Planning Justification Report Rezoning and Site Plan Control At 2822 Carp Road, Ottawa

December 23, 2020

The following section addresses comments and questions from City Staff and agencies.

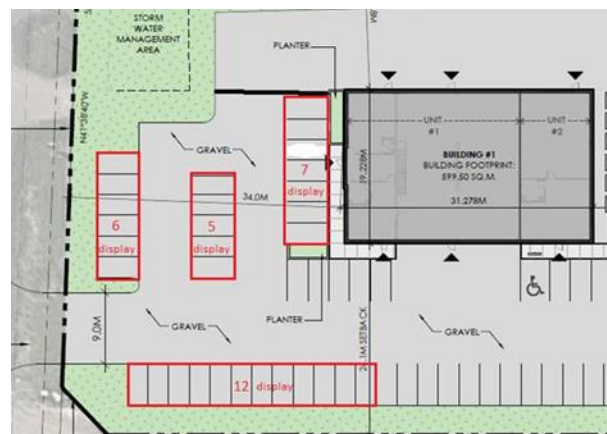
- *The proposed use appears to fit within the description of highway commercial uses permitted.*

The proposed use conforms to the description and general intent of the description of Highway Commercial contained in the CDP (2.5 Highway Commercial)

The Landscaping Plan

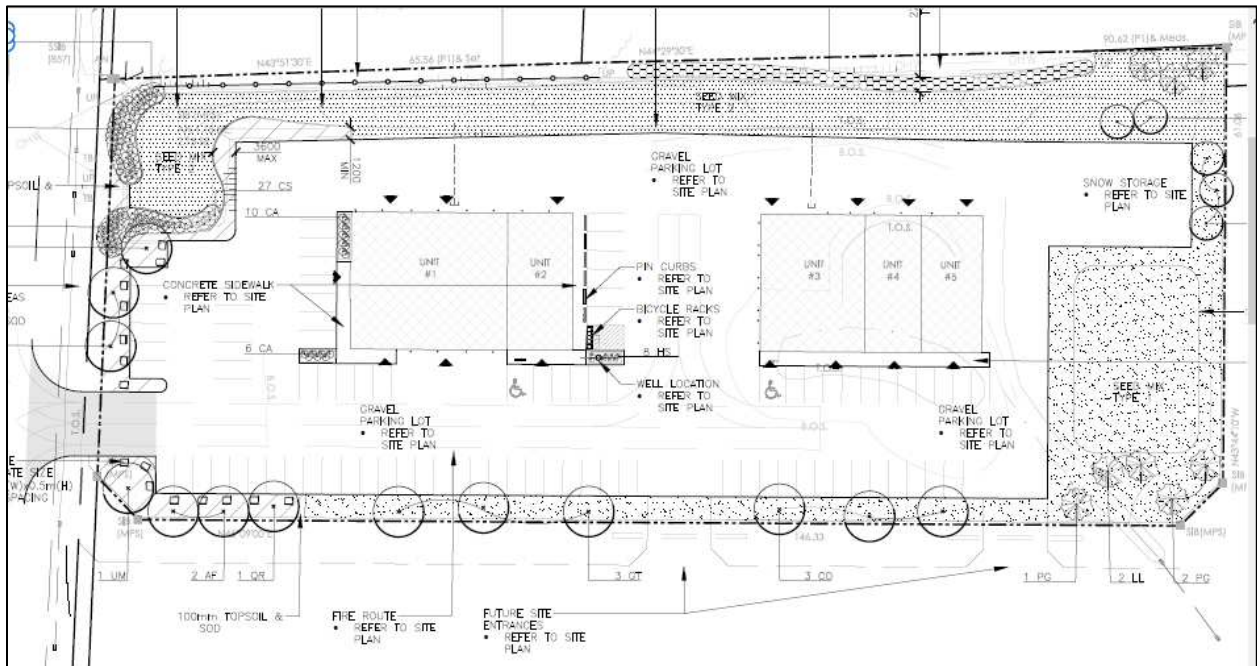
- d) *Preserve and add as many trees as possible on the site with tree planting within wide setbacks.*

- e) *Use landscaping, decorative fences, trees and/or shrubs in front of fencing to screen unsightly uses.*

There are no existing trees on the property; the landscape plan illustrates where new trees and vegetation will be planted within the setback areas on the property.

The Landscaping Plan shows a Plant List of the type and location of planting material that will provide screening and enhance the appearance of the Carp Road Corridor.

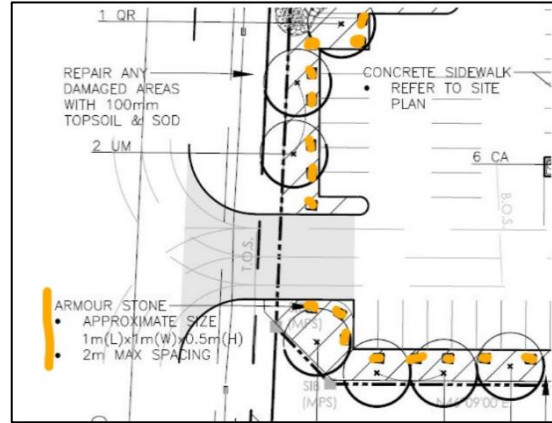
- f) *Encourage the use of shared entrances and signage off Carp Road wherever possible.*

Only one shared access is proposed from Carp Road onto the property that will be used by all tenants and visitors to the property.

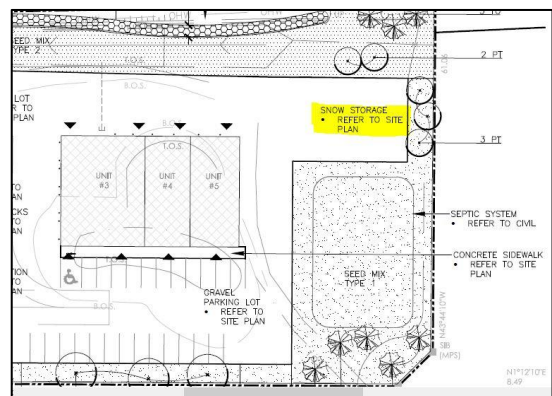
- *The site will need to be designed not to face snow storage in a location not visible from Carp Road.*

Snow Storage will be located at the rear of the property behind buildings and not visible from Carp Road.
